UNITED STATES PATENT AND TRADEMARK OFFICE

APPLICATION NO.	FILING DATE	FIRST NAMED INVENTOR	ATTORNEY DOCKET NO.	CONFIRMATION NO.
10/050,171	01/18/2002	Kenichi Watanabe	020029	7623
23850	7590	04/06/2005	EXAMINER	
ARMSTRONG, KRATZ, QUINTOS, HANSON & BROOKS, LLP 1725 K STREET, NW SUITE 1000 WASHINGTON, DC 20006			WARREN, MATTHEW E	
			ART UNIT	PAPER NUMBER
			2815

Office Action Summary	Application No. 10/050,171	Applicant(s) WATANABE	
	Examiner Matthew E. Warren	Art Unit 2815

DETAILED ACTION

FIG.77A

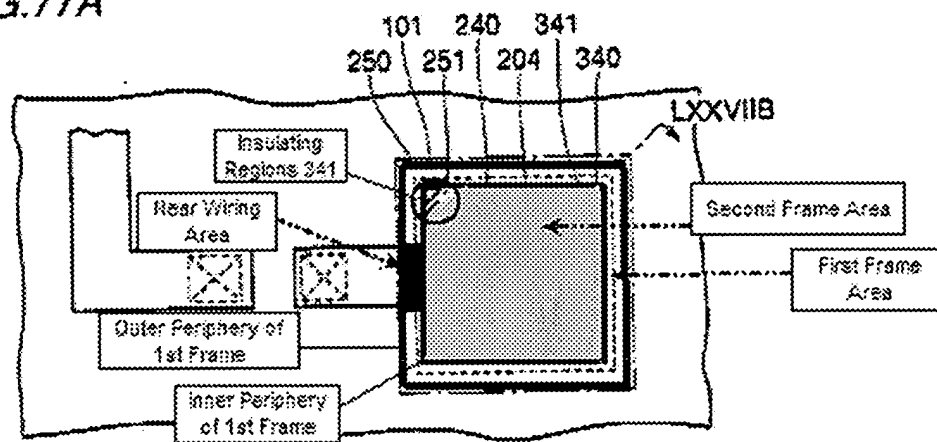
Since there is confusion as to what the near wiring area of Harada is, figure 77A has been provided below with the various portions labeled. As scene from the figure below, there is a first frame area and a second frame area within the first frame area. The outer periphery of the second frame area is actually the inner periphery of the first frame area. The insulating region (341) at each corner of the pad part is located within the second frame area. There is a near wiring area that extends into the first frame area. The insulating region (341) is not formed in the near wiring area. Harada was only deficient in showing that there are a plurality of insulating regions in the second frame

area, since the insulating region (341) is actually one continuous insulating layer surrounding the pad part (240). Lee shows in figure 8 that a plurality of insulating regions (925I or 945I) are formed in a second frame area (930 or 950) and thus cures the deficiencies of Harada.

FIG.77B

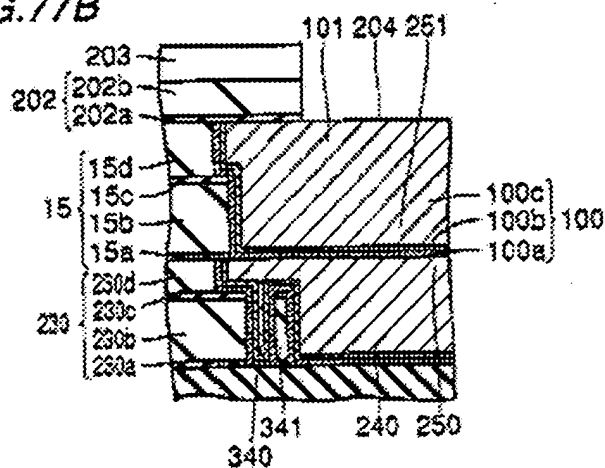
Furthermore, the applicant argues that the insulating regions, first pad, and wiring of Harada are not formed in the same layer as the first intra-layer insulating film because Harada has a multi-layer structure. However, an intra-layer insulating film may comprise several films. In Harada (fig. 77) films 230a, 230b, 230c, and 230d all make up

intra-layer insulating film 230. The applicant's specification (page 9) also states that the intra-layer insulating film comprises multiple layers.
